INITIAL FIRE SAFETY INSPECTION REPORT

KNIT CONCERN LTD. (EXTENSION)

RSC ID: 25933

Date: 22-Jan-2025

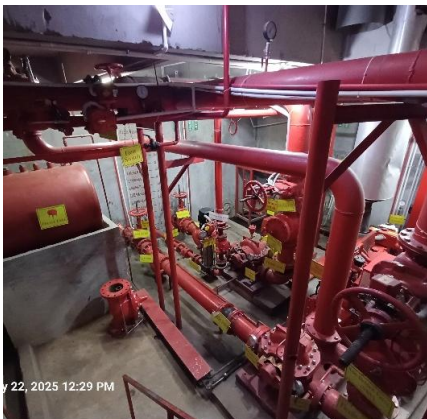
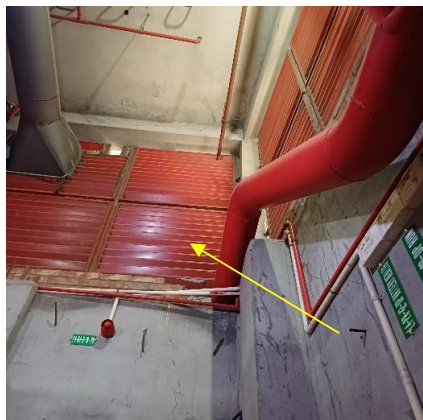
30	Fire Rated Construction	Thermal Boiler is not separated by fire rated construction from the Dyeing KCL Shed. (Thermal boiler Shed)	Any room or space housing boilers or other heat producing equipment shall be separated from other occupancies by a minimum 1 hour construction or by a minimum spatial separation of 3 m (10 ft) where located exterior to the building.	Within 3 months

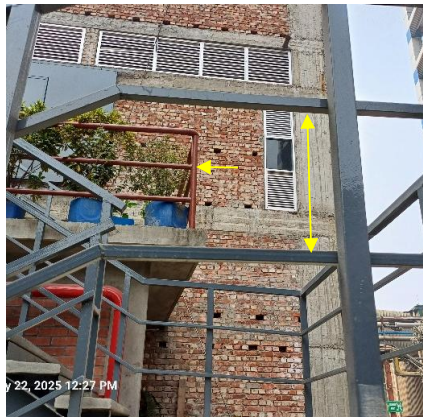
32	Fire Rated Construction	The main structural element of the interim building is constructed by steel which is non-rated and were found in exposed condition without any fire protection. (Building-6 (Compressor, fire panel & pump room Building))	The building shall be type-I or II construction. So, provide require rating in the structural elements of the building. Consult with a qualified fire protection engineer. BNBC 2006-Table 3.2.4	Within 6 Months

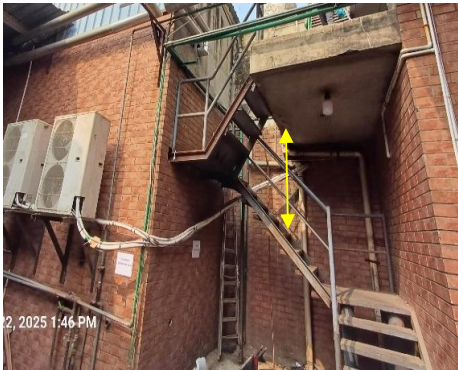
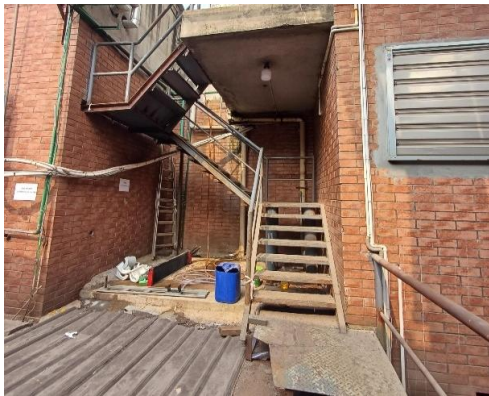
46	Means of Egress	A single means of exit has been provided for the second floor. (Diesel Generator & Chiller Building)	The number of means of egress from any floor, story or portion thereof shall not be less than 2 except where a single exit is permitted by RSC Technical Guideline (Standard), section 6.6.2 Provide additional exit and ensure that the exit doors or means of egress openings are located a distance apart as per RSC Technical Guideline (Standard) section of 6.6.6	Within 3 Months

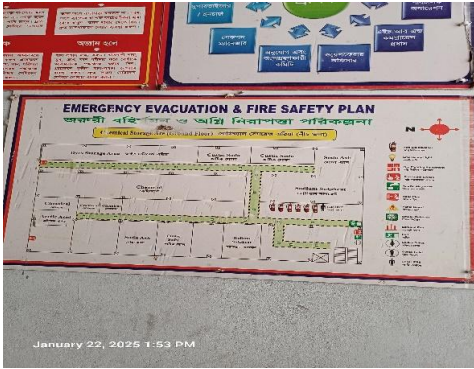
49	Means of egress	Building did not have occupant load signs at the required locations. (Diesel Generator & Chiller Building)	Provide occupant load signs at required locations.	Within 1 month

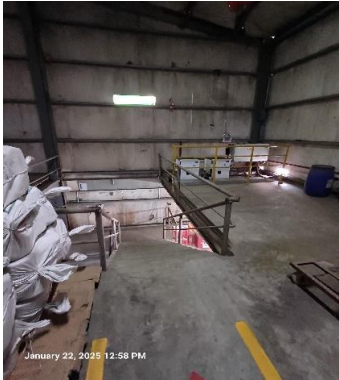
68	Fire Rated Construction	The required fire separation distance for Yarn Godown Shed does not comply with the requirements of BNBC 2006. (Yarn Godown Shed)	The exterior walls shall have a fire resistance and opening protection as specified in BNBC 2006, Tables 3.2.2 and Part 3 Section 2.4.1.3.	Within 6 Months
69	Fire Rated Construction	Elevator shafts are directly open into the floors. (Yarn Godown Shed)	Provide a minimum 2-hr fire rated construction to separate the elevator shaft from each floor level. Seal all penetrations and openings in floors/ceiling assemblies to maintain the required fire separation.	Within 3 months

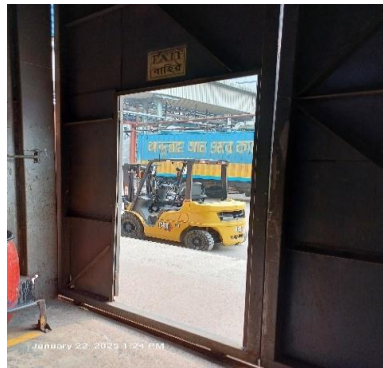
80	Means of Egress	Storage room discharges directly into exit stair enclosure. (Raw Fabric Store Shed)	Openings from exit enclosure to storage room spaces shall be provided with a vestibule with fire rated construction and openings. Provide a 1.5 hr. fire rated door on the exit stair side and a 1-hr. fire rated door on the Store room side. Ensure that the fire rating of the vestibule construction matches that of the exit stair enclosure.	Within 3 months
81	Fire Rated Construction	Elevator shafts are directly open into the floors. (Raw Fabric Store Shed)	Provide a minimum 2-hr fire rated construction to separate the elevator shaft from each floor level. Seal all penetrations and openings in floors/ceiling assemblies to maintain the required fire separation.	Within 3 months
